[Docket No. 95–SW–04–AD]

Airworthiness Directives; Societe Nationale Industrielle Aerospatiale and Eurocopter France Model AS 350B, BA, B1, B2, and D, and Model AS 355E, F, F1, F2, and N Helicopters

ACTION: Notice of proposed rulemaking (NPRM).

DETAIL 1

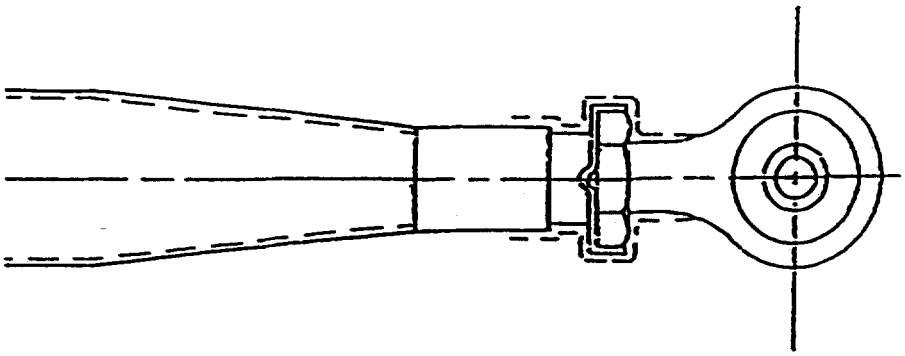
(a) Within 100 hours time-in-service (TIS) after the effective date of this AD, remove the forward lower fairing and visually inspect the cyclic pitch change control rod (rod), P/N 704A34–113–279, to determine whether the end fittings have been safetied (see Figure 1, Detail 1, tabs bent around the adjustment nut).

(b) If the visual inspection indicates that the rod end fittings have been safetied, reinstall the forward lower fairing.

DETAIL 2

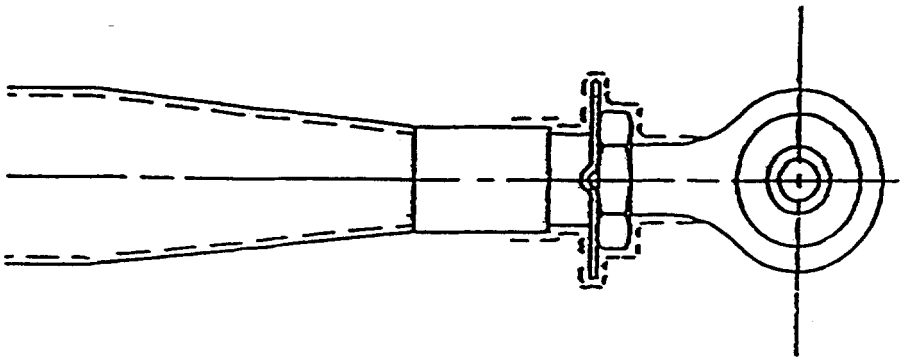
(c) If the visual inspection indicates that the rod end fittings have not been safetied (see Figure 1, Detail 2, tabs not bent around the adjustment nut), accomplish the following in accordance with the applicable maintenance manual:

(2) Remove the rod and replace it with an airworthy rod on which the rod end fittings have been safetied.

(3) Reinstall the forward lower fairing.

(4) Verify proper operation of the cyclic control.
